U. S. NAVY ELECTRONICS LABORATORY, SAN DIEGO, CALIFORNIA

1050  
NEL/Technical Memorandum  
TECHNICAL MEMORANDUM TM-1050

AN/SQS-23 (PAIR) SONAR LETTER REPORT (U)

22 September 1965

Figure 1 Proposed PPI Display  
Task No. 8

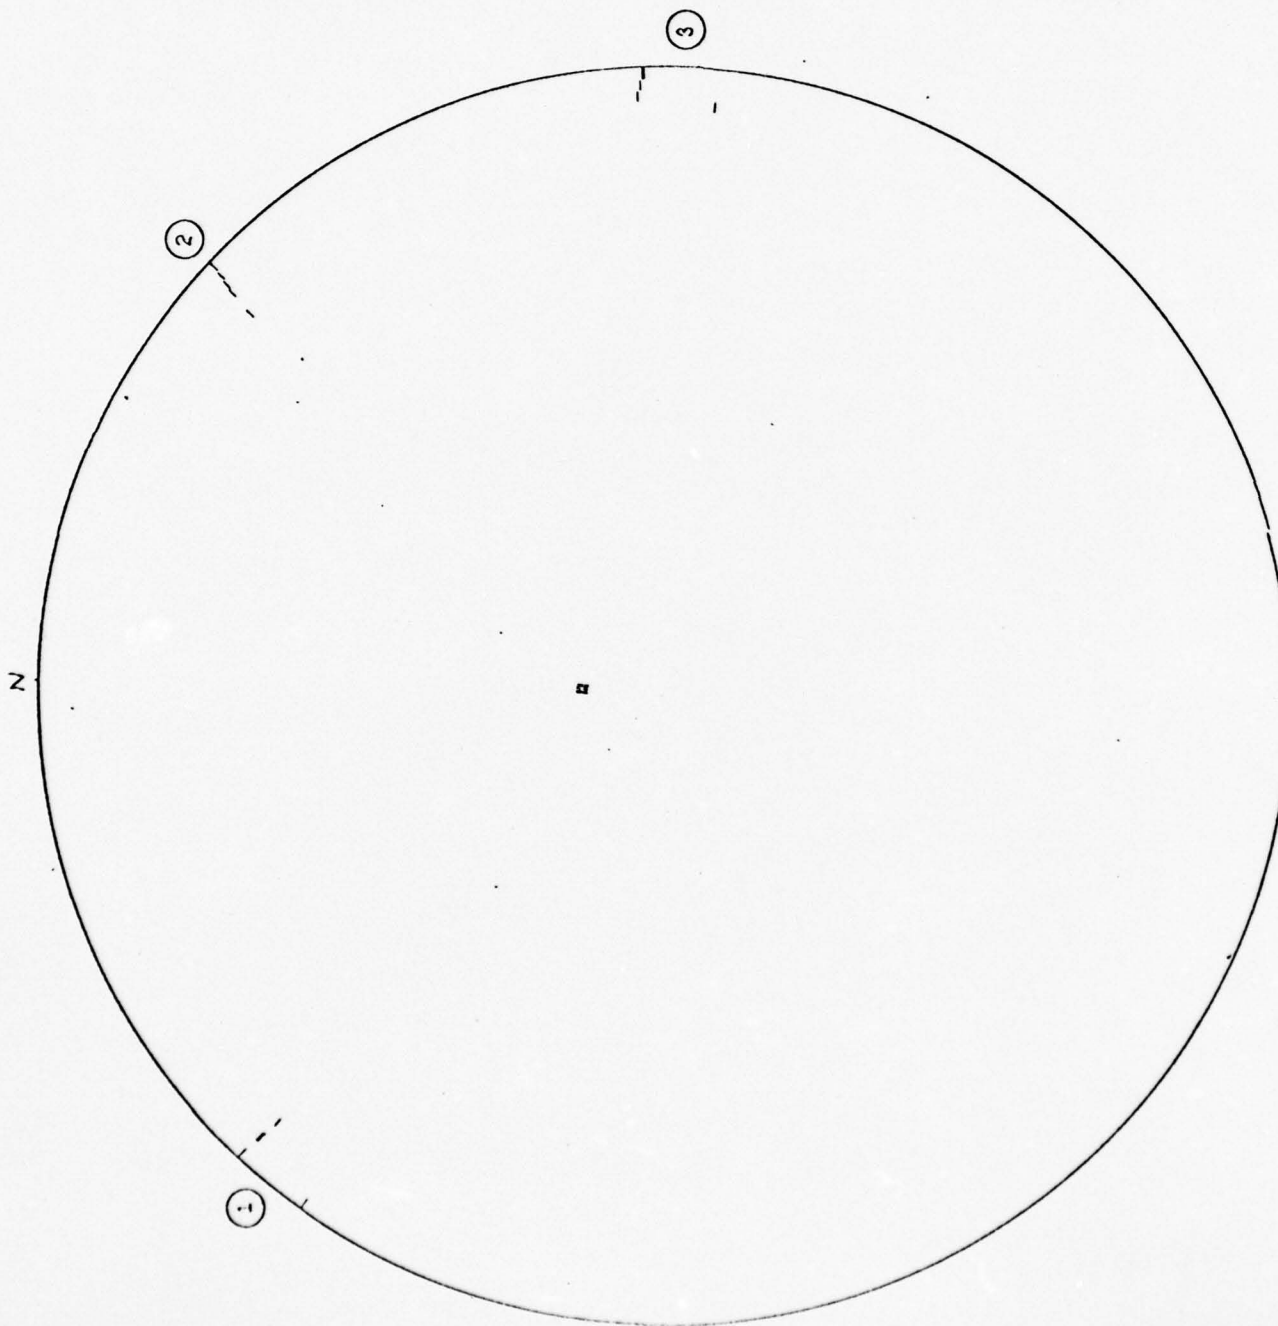
After considering the proposed spoked PPI display (See Figure 1) in some detail, we designed a B-scan format for the same size CRT (See Figure 2) for comparison purposes. We will illustrate that this B-scan has a number of significant advantages over the proposed PPI. Included in these advantages are larger and more easily distinguished event mark sizes and spacings, more easily detectable patterns for targets moving in either range or bearing, more effective utilization of the available display area, and better correlation between track ball motion and cursor motion.

Utilization of the display area on the proposed 10" circular PPI screen is very poor (19.5%). The proposed B-scan utilizes 62.8% of the rectangular 8.4" x 6" area selected. The larger range dimension on the proposed B-scan (6" vs. 4.4" for the PPI) provides a longer event mark and has the added advantage of easier positioning of the cursor in range for handoff to the TCD. This is particularly critical in the single ping mode where the detection display has 240 range bins. This range dimension could be further increased without an objectionably large CRT by going to a rectangular tube screen.

2. Section 3.4.5.12 - Change: "For search operations a PPI-scan shall be provided" to: "For search operations a PPI and/or B-scan shall be provided". Add: "Choice of PPI and/or B-scan for search operations will be decided by ASWSPO after further simulation and analysis". Therefore delete Figure 6.

Figure 1  
Percent of Maximum Amplifier Power Used  
versus  
Source Level

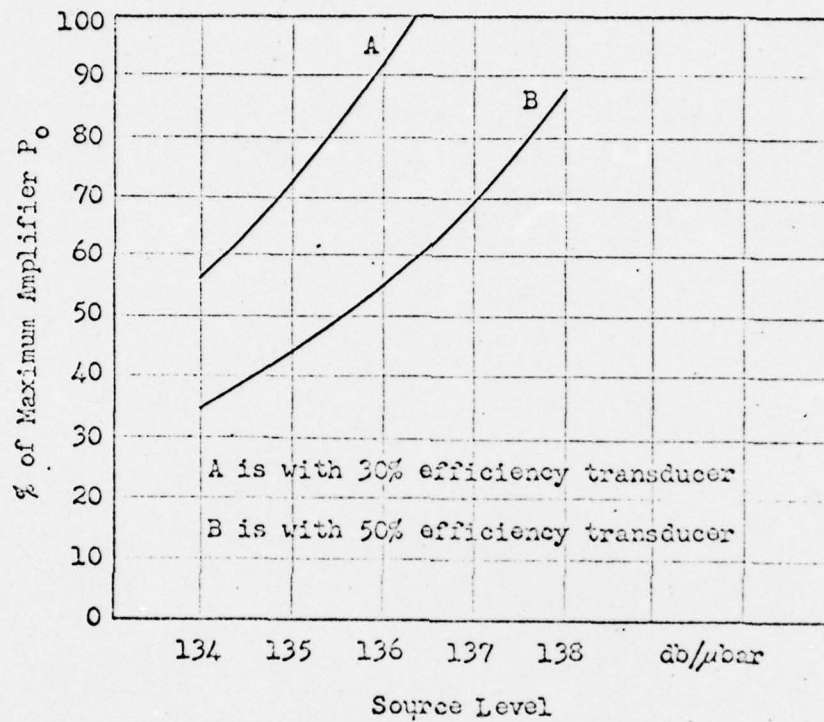
The stated efficiency of the Harris TR-191 and Massa TR-028 transducers is greater than 60%. Specifications for the Sangamo TR-177, Bendix TR-152 and Raytheon TR-197 require only 30%. Since the TRAM modification reduces the power handling capabilities of the transmitter section, the lower efficiency of the later group would require operating the amplifiers above 70% of maximum capability to maintain satisfactory source level (Figure 1). This additional load will reduce the transmitter reliability.

Figure 1  
Percent of Maximum Amplifier Power Used  
versus  
Source Level

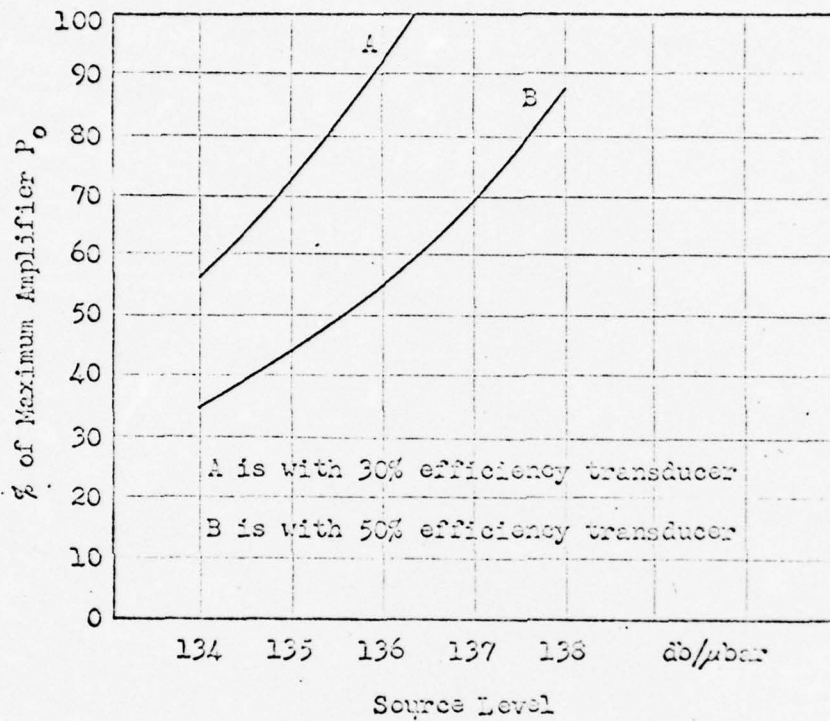
Allowing a 30% safety factor and using 70% of the maximum transmitter power capabilities, assures that some reserve power remains to handle load mismatch. Figure 1 shows that a source level of 135 db ref  $\mu$ bar at one yard leaves ample reserve amplifier power when coupled to a 50% efficient transducer but that no reserve is left when coupled to a 30% efficient transducer.

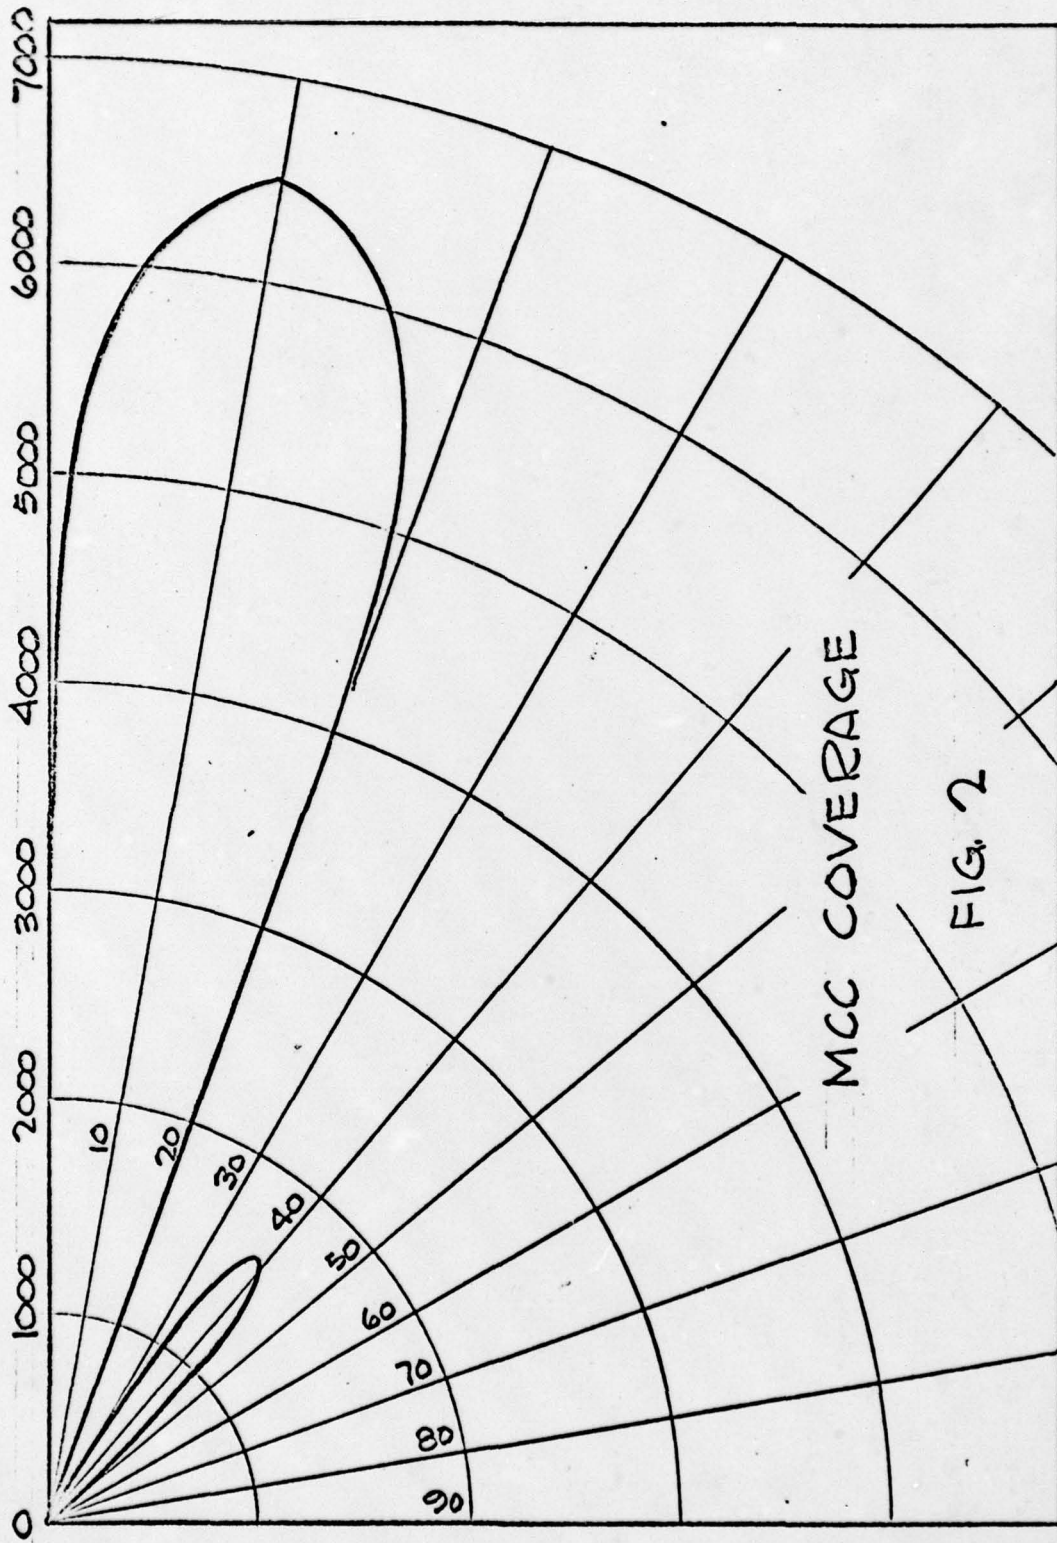
Figures 1 and 2 show the calculated areas of active transmit receive coverage and lack of coverage due to transmit and receiving beam patterns. The combined transmit-receive beam pattern was computed using the standard sonar equation and the following data:

Figures 1 and 2 depict areas of no coverage in the MCC Mode, therefore no tracking information would be sent to fire control for a target in these areas. Further studies on active and passive beam forming should be made to determine whether or not this condition is objectionable.
